## INTERIOR ENVIRONMENTS JSP13-18

Consideration of the request of Interior Environments for Preliminary Site Plan and Stormwater Management Plan approval. The subject property is located in Section 17 at 48700 Grand River Avenue, on the north side of Grand River Avenue, east of Wixom Road in the B-3, General Business District. The subject property is 1.36 acres and the applicant is proposing to expand the parking area, update the façade and make other minor improvements.

Approval/denial of the Preliminary Site Plan and Stormwater Management Plan.

## PLAN REVIEW CENTER REPORT

**Image above:**

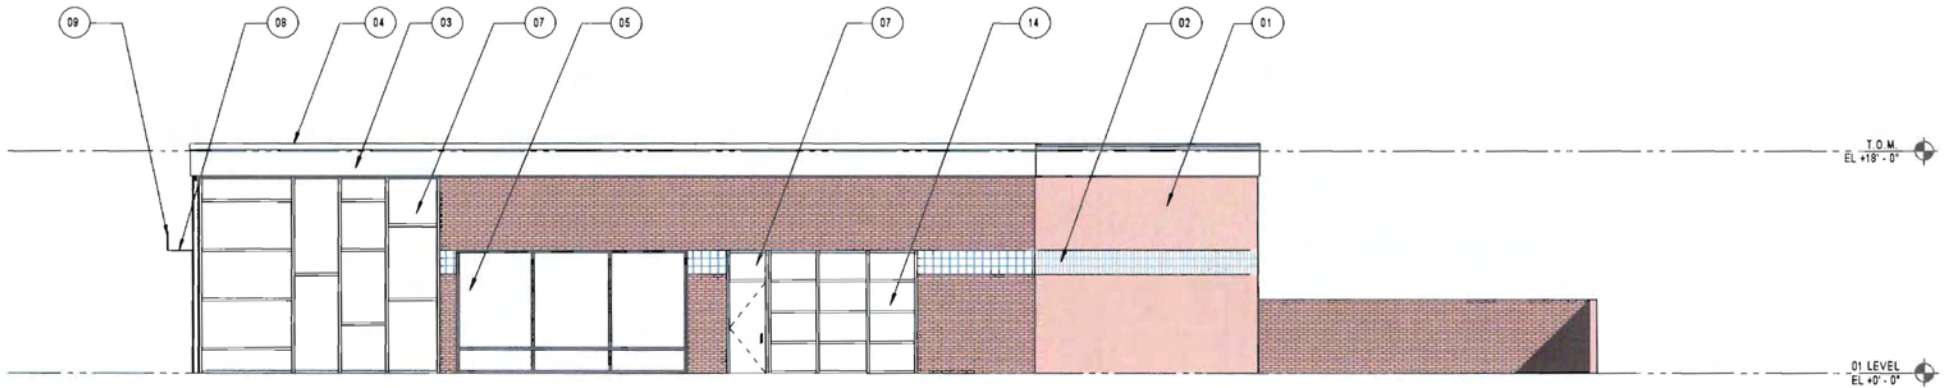
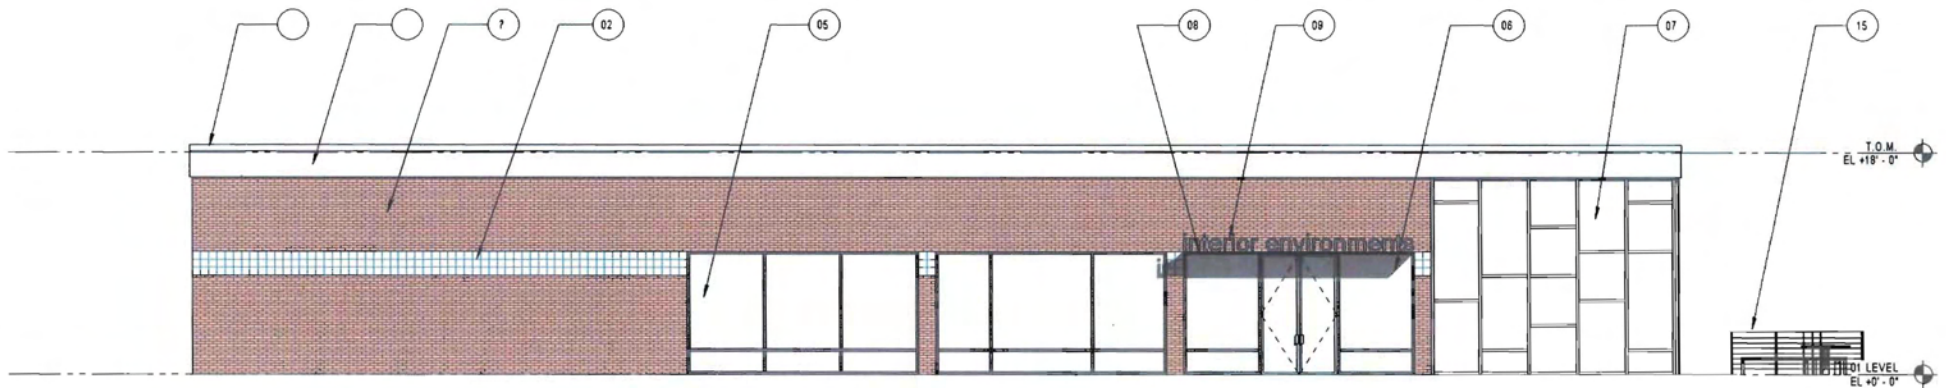
The corner of the building is squared off using an aluminum and glass curtain wall. The move increases space and light, reinforces brand identity, and layers the customer experience. Shifting the building entry away from the corner produces better interior spatial arrangements and new showroom area.

Existing chamfered corner entry with massive aesthetic column.
